SIB 41 06 25

DELIVERY STOP: BULKHEAD HEAT INSULATION

This Service Information Bulletin (Revision 1) replaces SI B41 06 25 **dated July 2025**.

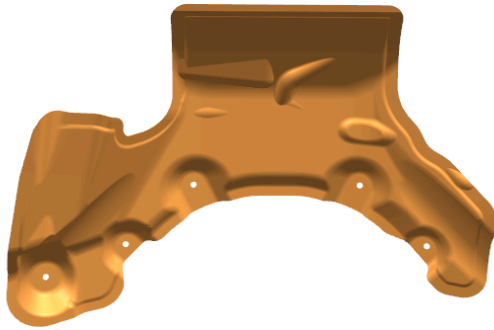
The heat insulator (highlighted in orange) for the bulkhead was not installed. Thermal overload of the components located in the area cannot be ruled out.

Install the heat insulator onto the bulkhead.

1. Remove both catalytic converters follow the repair instructions listed in ISTA/AIR 18 32 070.
2. Remove the right-side control unit holder following the repair instructions listed in ISTA/AIR 12 52 032.
3. Remove the electric auxiliary heater following the repair instructions listed in ISTA/AIR 64 12 320.
4. Install the heat insulator onto the bulkhead.
